Burrendong Wind Farm Amendment Report

Noise and Vibration Memorandum

Project:	Burrendong Wind Farm	Document No.:	Mm 001 R03		
To:	Burrendong Wind Farm Pty Ltd	Date:	5 March 2026		
Attention:	Jane Ewers	Cross Reference:	Rp 002 r02 20200219		
Delivery:	Email	Project No.:	20251010		
From:	Harsh Vardhan Sah	No. Pages:	21	Attachments:	No
Subject:	Response to RFI by DPHI

Figure 1: Estimated airblast overpressure levels for $K_a = 50$ and $a = -1.45$

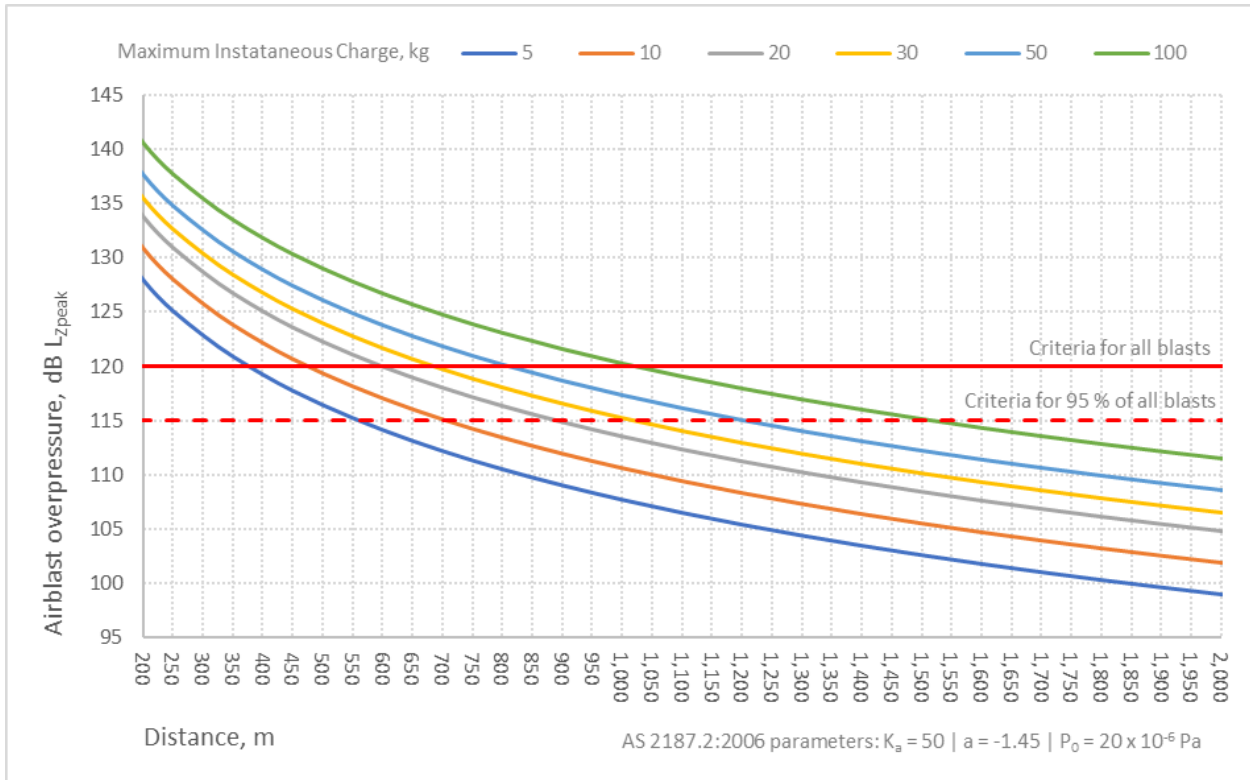
Estimated airblast overpressure levels are presented in Figure 1 for a range of separating distances and maximum instantaneous charge weights. The estimated levels are based on confined blasthole charges and assumed site characteristics.³

The criteria specified in the ANZEC 1990 Report, set out in Section 3.5.3 of the EIS Noise Assessment, are also shown in Figure 1.

- Estimated airblast overpressure levels at the nearest non-associated receivers are below the criteria set for all blasts.
- Estimated ground vibration levels at the nearest non-associated receivers are below the criteria set for all blasts.

Figure 2: Estimated ground vibration levels for $K_g = 1140$ and $B = 1.6$

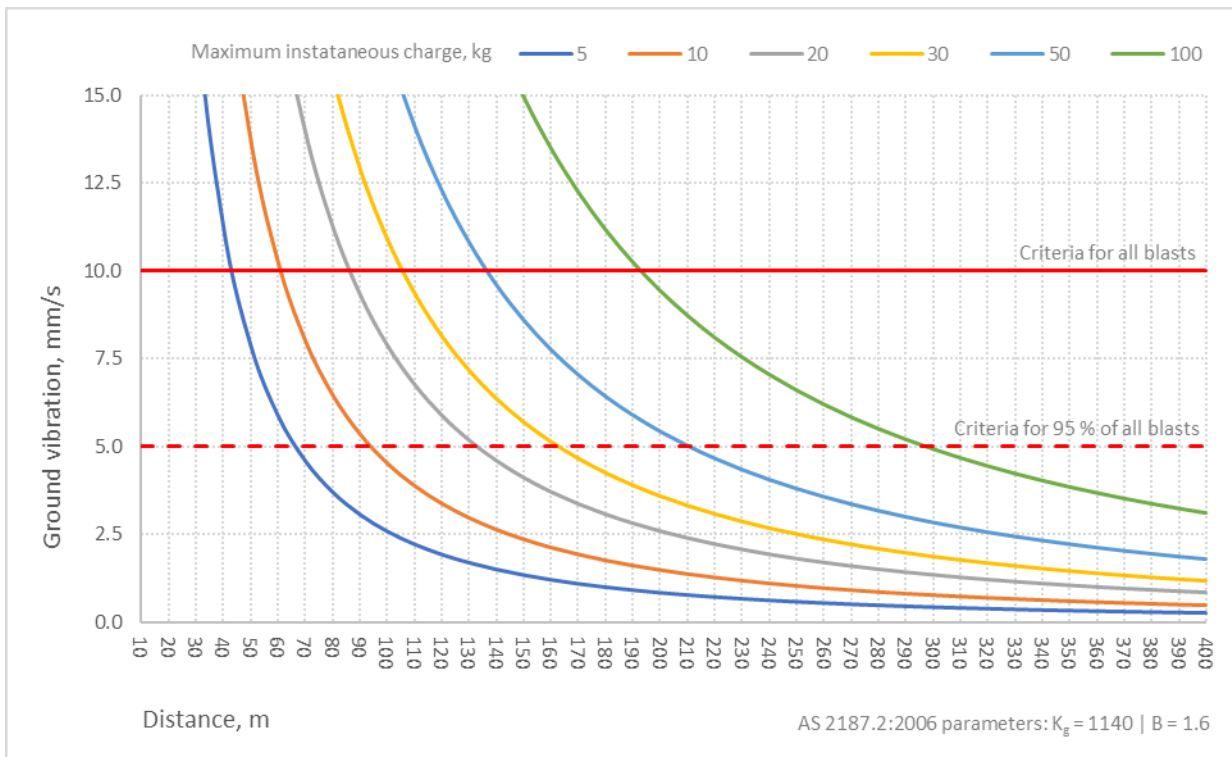
Estimated ground vibration levels are presented in Figure 2 for a range of separating distances and maximum instantaneous charge weights. The estimated levels are based on assumed site characteristics.⁴

The criteria specified in the ANZEC 1990 Report, set out in Section 3.5.3 of the EIS Noise Assessment, are also shown in Figure 2.

Figure 3: Non-associated receivers within 400 m of the proposed public road upgrades

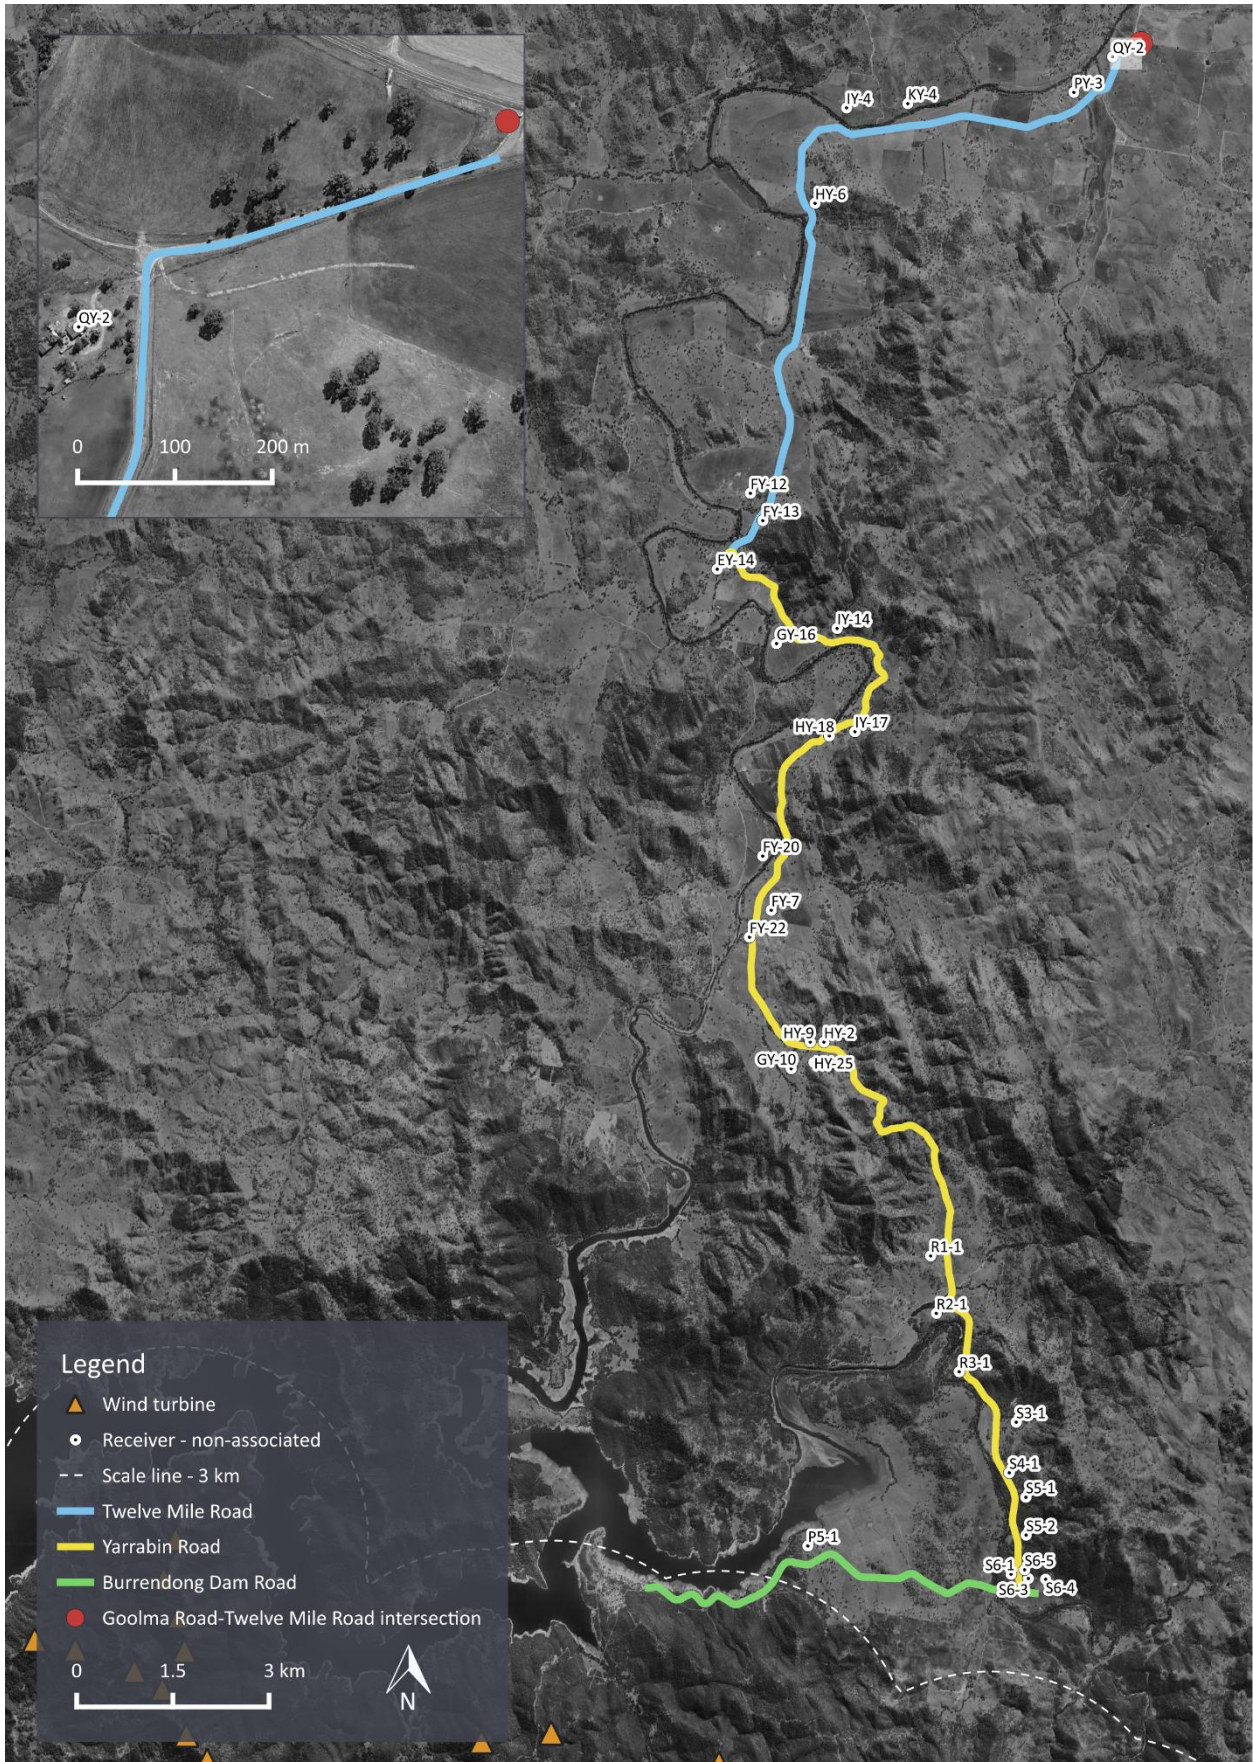
The closest receiver to the proposed Goolma Road and Twelve Mile Road intersection works, QY-2, is located over 460 m away from the start of the works area. Therefore, no receivers are expected to be within the noise affected management level for the intersection upgrade works. An indicative location for the intersection upgrade works has been provided by Ark Energy and shown in Figure 3.

Ark Energy has provided additional GIS data on 21 January 2026 that determines receivers within the 400 m setback distance described above. These are detailed in Table 12 and shown graphically in Figure 3.

Revised assessment should be carried out once a construction contractor is appointed and refined details are available for work processes, plant, and equipment specific to the public road upgrades. Where predicted noise levels are above the noise affected management levels then specific noise management requirements designed to mitigate the impact of public upgrade works should be determined. The detailed assessment and associated noise management requirements should be detailed in the construction noise and vibration management plan (CNVMP) described in Section 9.6 of the EIS Noise Assessment.

Figure 5: Highest predicted noise level contours

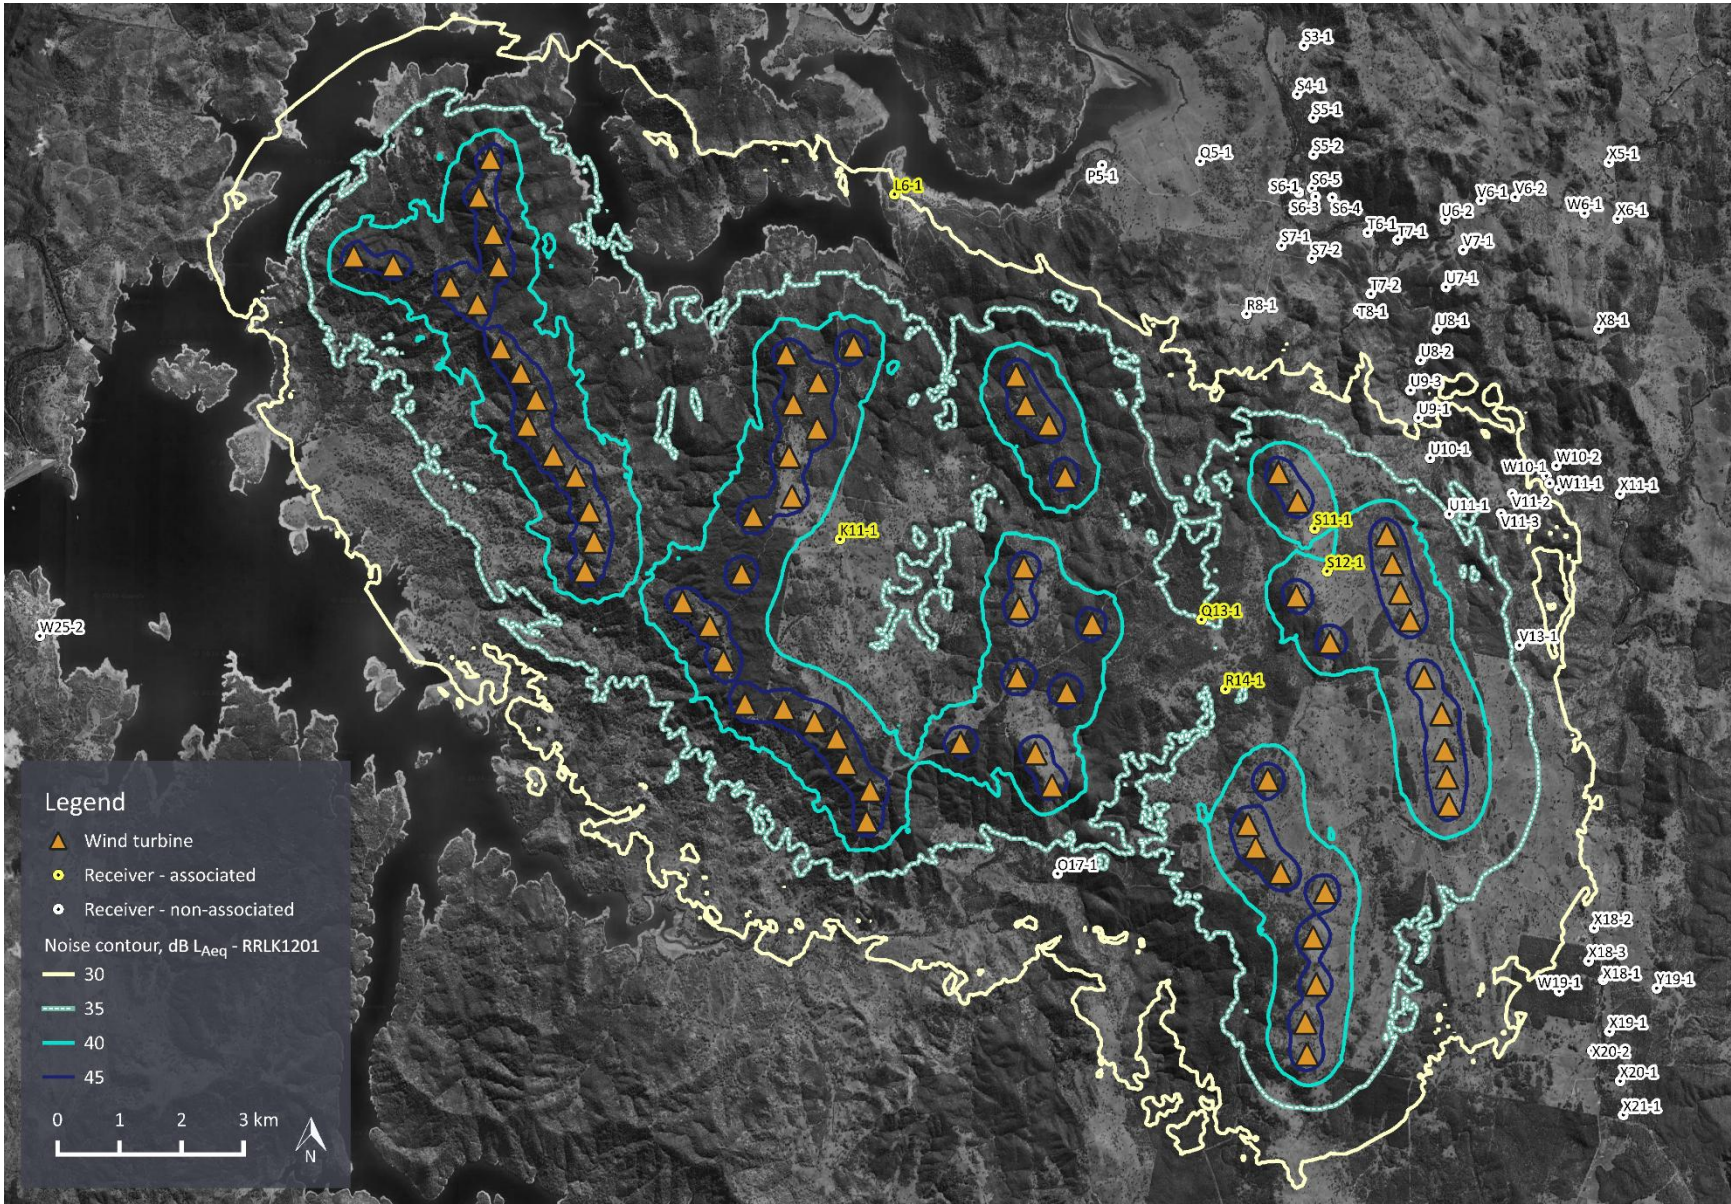
Figure 5 supersedes Figure 2 in Section 6.4 of the EIS Noise Assessment.
